SERVICE MANUAL

AIR CONDITIONER

< Wireless remote controller kit >

1. THE CURRENT MODEL AND THE NEW MODEL COMPARISON LIST

3-1. 4-Way Cassette Type

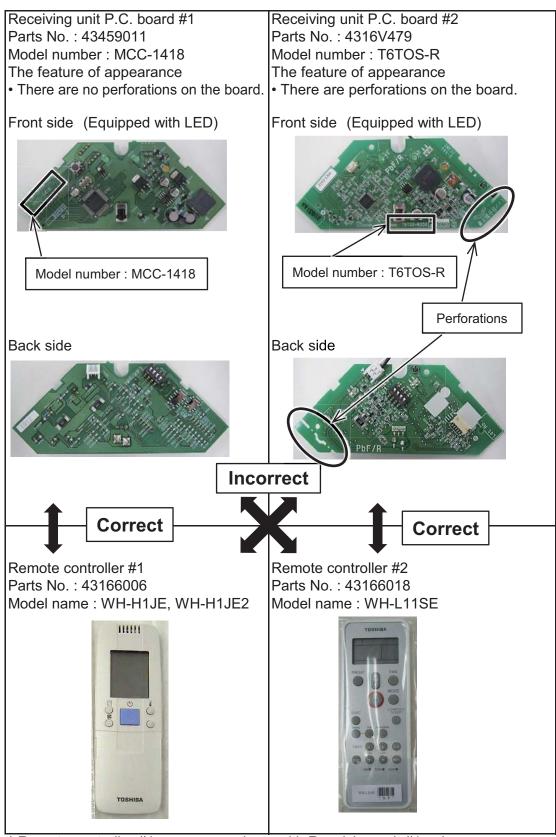
Location No.	Part No.		Description	Q'ty/
	RBC-AX31U(W)-E*	RBC-AX32U(W)-E	Description	Set
353	43459011* -	> 4316V479	P. C. BOARD ASSY, REMOTE RECEIVER	1
354	43462010	←	COVER, WRS	1
355	43461006	←	SHEET	1
356	43108018	←	COVER, PANEL WRS	1
358	43460126	←	LEAD	1
_	43166006* -	→ 43166018	REMOTE CONTROLLER	1
_	_	43F83071	HOLDER, REMOTE, CONTROLLER	1

Location No.	Part No.		Description	Q'ty/
	RBC-AX31U(WS)-E*	RBC-AX32U(WS)-E	- Description	Set
353	43459011* -	→ 4316V479	P. C. BOARD ASSY, REMOTE RECEIVER	1
354	43462010	←	COVER, WRS	1
355	43461006	←	SHEET	1
357	43108019	←	COVER, PANEL WRS	1
358	43460126	←	LEAD	1
_	43166006* -	→ 43166018	REMOTE CONTROLLER	1
_	_	43F83071	HOLDER, REMOTE, CONTROLLER	1

^{*} This parts is discontinued.

Replacement parts can use the current model.

Type: 4-Way Cassette Type

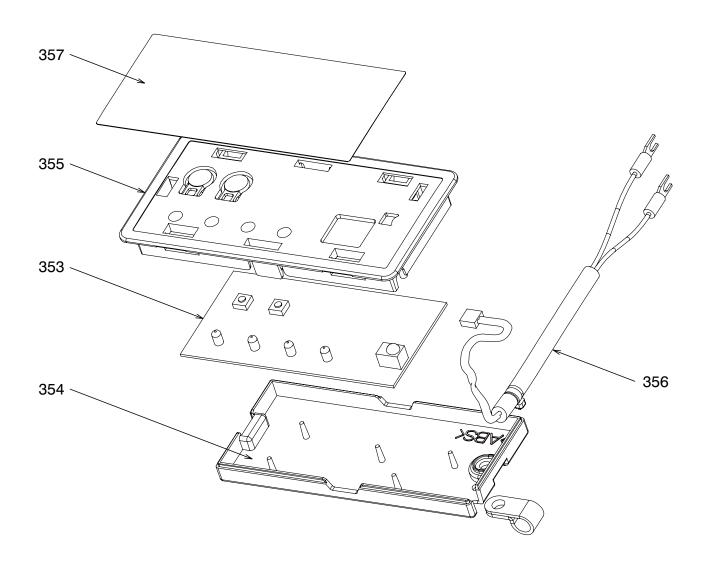
^{*} Remote controller #1 can communicate with Receiving unit #1 only, also Remote controller #2 can communicate with Receiving unit #2 only.

3-2. Ceiling Type and 1-Way Cassette SH Type

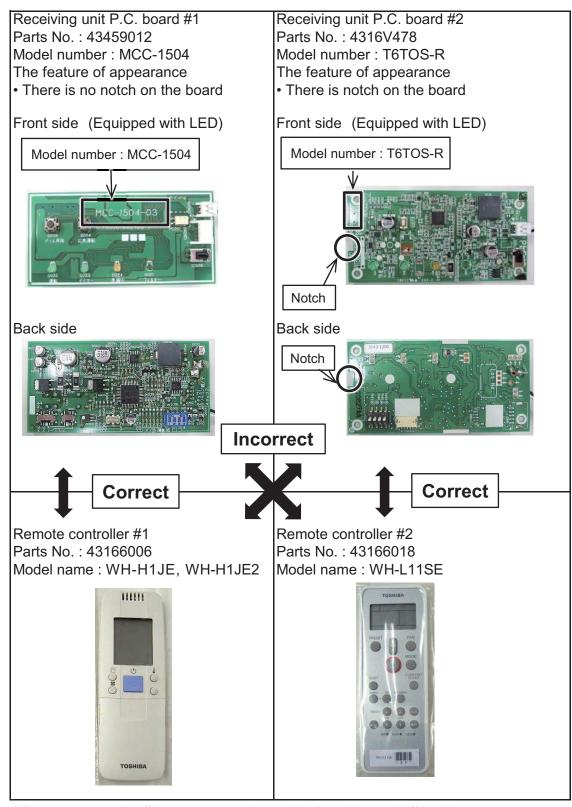
Location No.	Part No.			O:: /
	RBC-AX22CE, RBC-AX22CE2	RBC-AX32CE2	Description	Q'ty/ Set
353	43459012* -	→ 4316V478	P. C. BOARD	1
354	43408030	←	COVER, RECEIVER	1
355	43108014	43108028	BASE, RECEIVER (+MARK, TOSHIBA)	1
356	43160601	←	LEAD	1
357	43108021	_	MARK, TOSHIBA	1
	43166006* -	→ 43166018	REMOTE CONTROLLER	1
	<u> </u>	43F83071	HOLDER, REMOTE, CONTROLLER	1

^{*} This parts is discontinued.← Replacement parts can use the current model.

Type: Ceiling Type and 1-Way Cassette SH Type

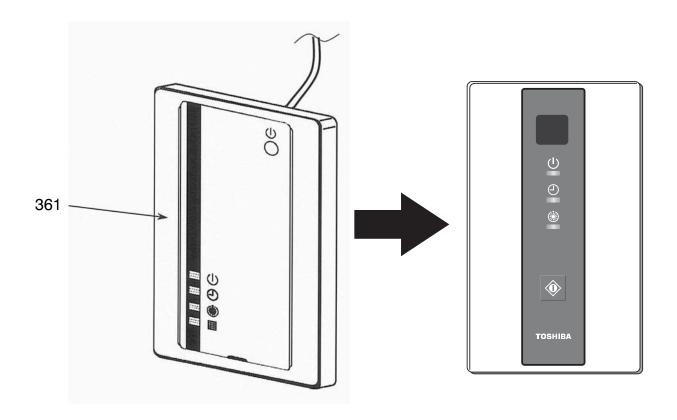
^{*} Remote controller #1 can communicate with Receiving unit #1 only, also Remote controller #2 can communicate with Receiving unit #2 only.

3-3. Stand-alone Type

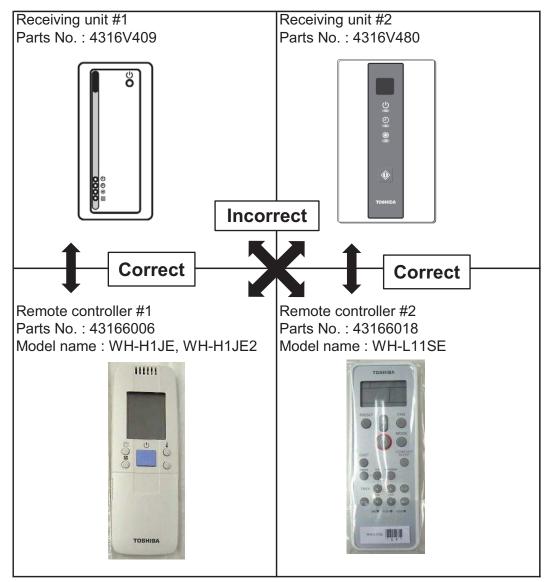
Part No.			Q'ty/
Location No.	TCB-AX21E, TCB-AX21E2	TCB-AX32E2	Description	
361	4316V409* -	> 4316V480	RECEIVER, UNIT	1
_	43166006* -	→ 43166018	REMOTE CONTROLLER	1
_	_	43F83071	HOLDER, REMOTE, CONTROLLER	1

^{*} This parts is discontinued.

Type: Stand-alone Type

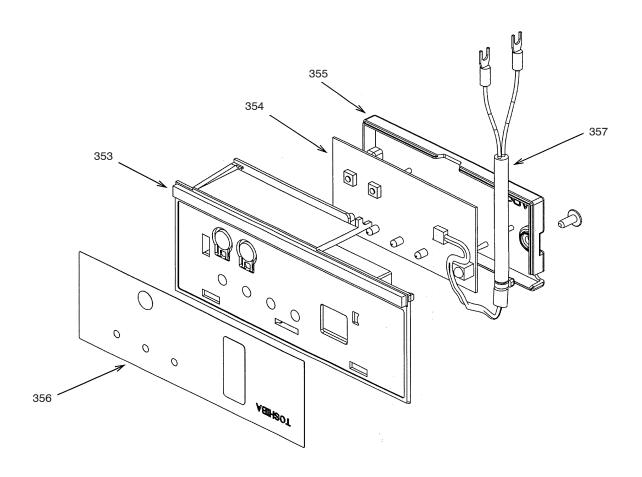
^{*} Remote controller #1 can communicate with Receiving unit #1 only, also Remote controller #2 can communicate with Receiving unit #2 only.

3-4. 2-Way Cassette Type

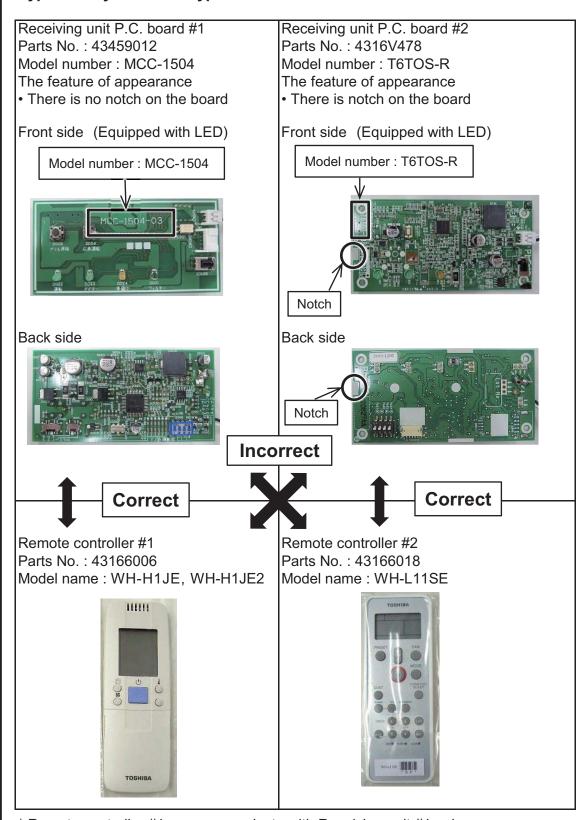
Location	Part No.		Description	Q'ty/
No.	RBC-AX23UW(W)-E*	RBC-AX32UW(W)-E	Description	Set
353	43408035	←	BASE, WIRELESS	1
354	43459012* -	> 4316V478	P. C. BOARD	1
355	43408030	←	COVER, RECEIVER	1
356	43108026	←	MARK, TOSHIBA	1
357	43460116	←	LEAD	1
_	43166006* -	→ 43166018	REMOTE CONTROLLER	1
_	_	43F83071	HOLDER, REMOTE, CONTROLLER	1

^{*} This parts is discontinued.

← Replacement parts can use the current model.
